RFP TM-24-01
Technology for Buses
Questions and Answers #1
November 17, 2023

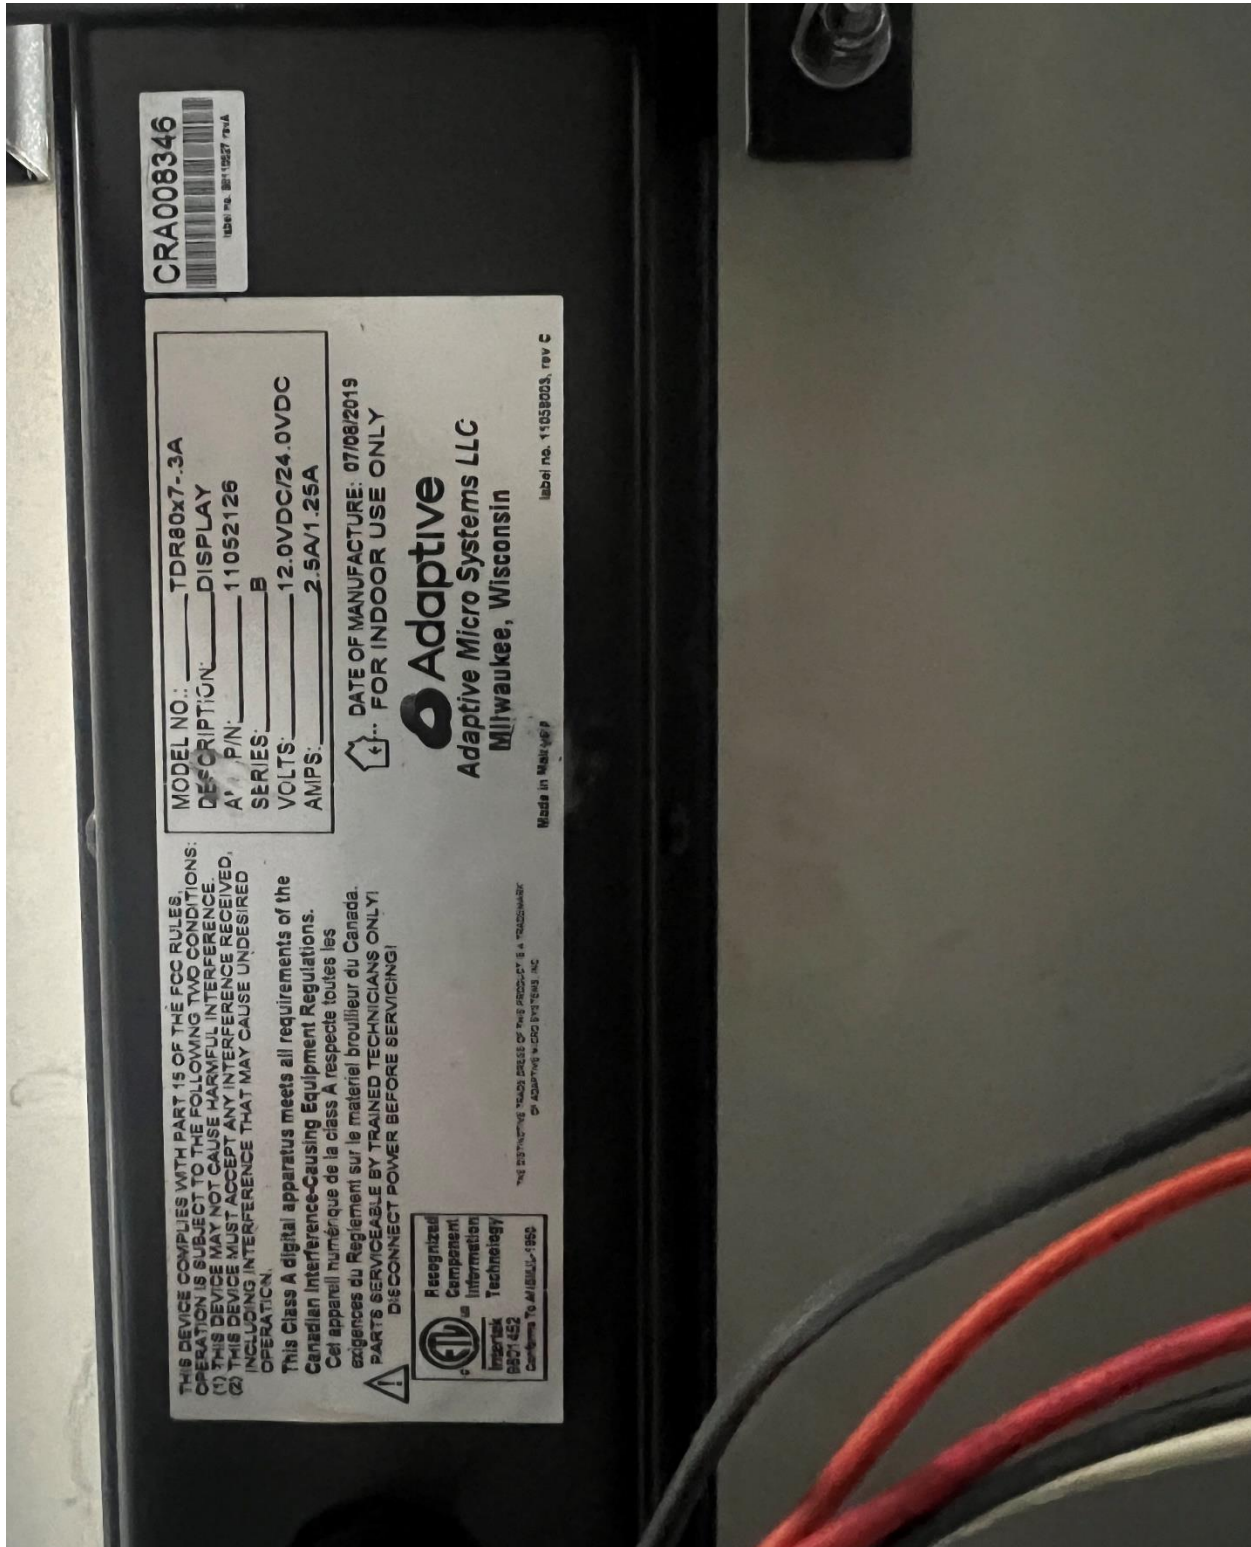
A89. No.

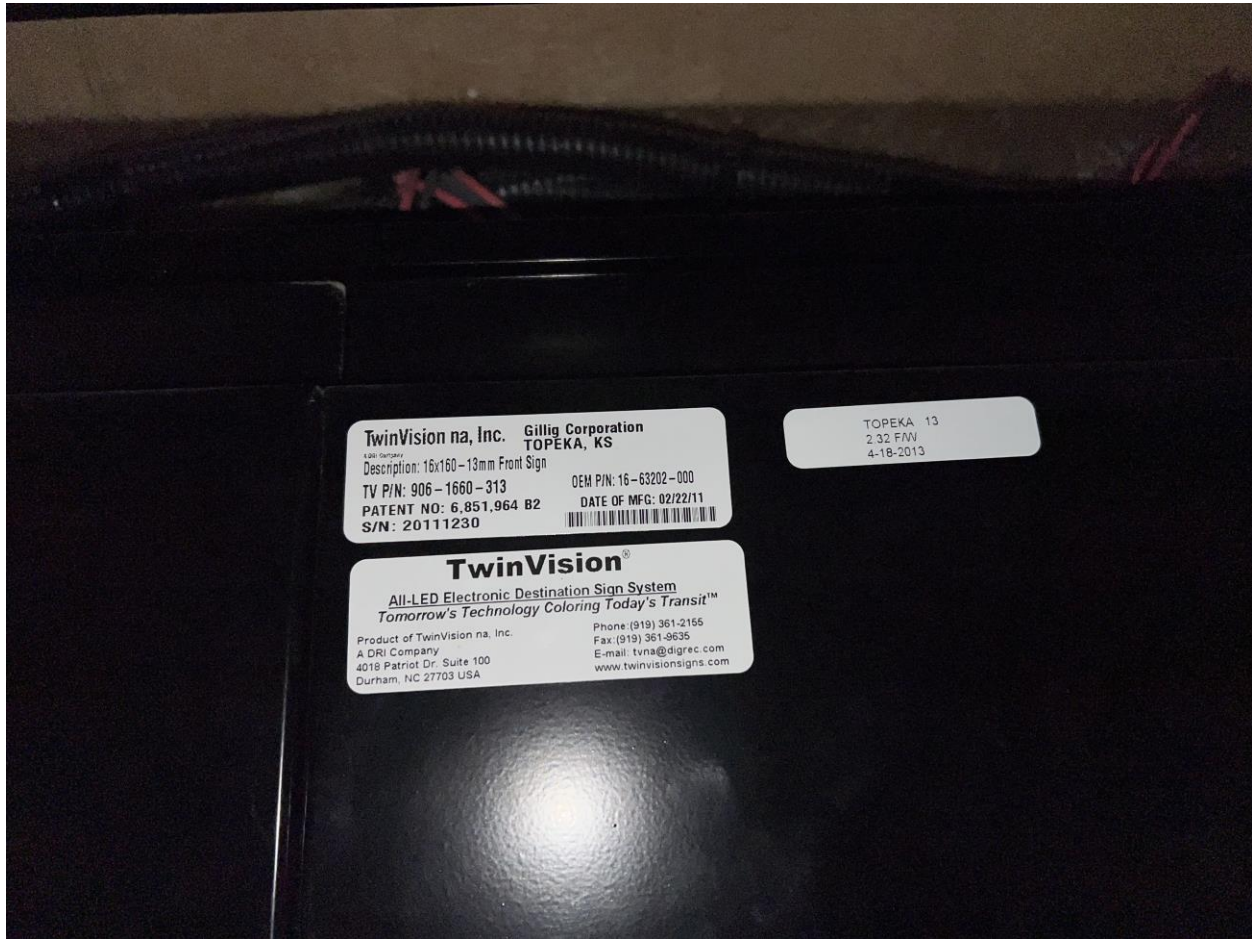
A79. Need clarification. What are you asking the J1708 are compatible with?

Q80. What is make and model of the signage at station/ stops?
